HOG1000 HOG500

Control Consoles

TBJLT111.doc

Resistor Changes for Replacement LCD Module

Playback Card Resistor Locations, viewed from solder side

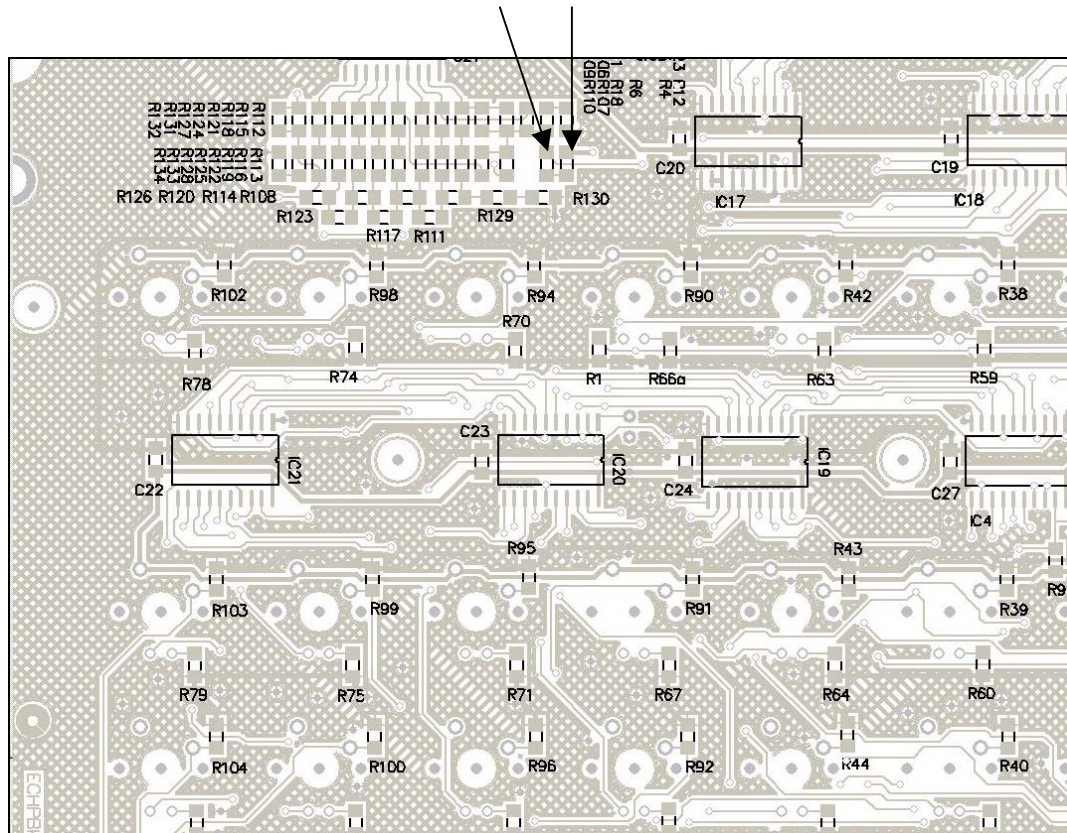
The new LCD requires a small number of resistor changes to accommodate a difference in contrast range. The resistor changes for the Playback Card are detailed in Table 1; the resistor changes for the Menu card are detailed in Table 2.

| Resistor | Original Seiko L4052-21J000 Jands #ZLC1100 | New Newtec WH4002A Jands #ZLC1105 |
|----------|---|--------------------------------------|
| R4 | 4K7 | 10K |
| R12 | 2K2 | 10K |
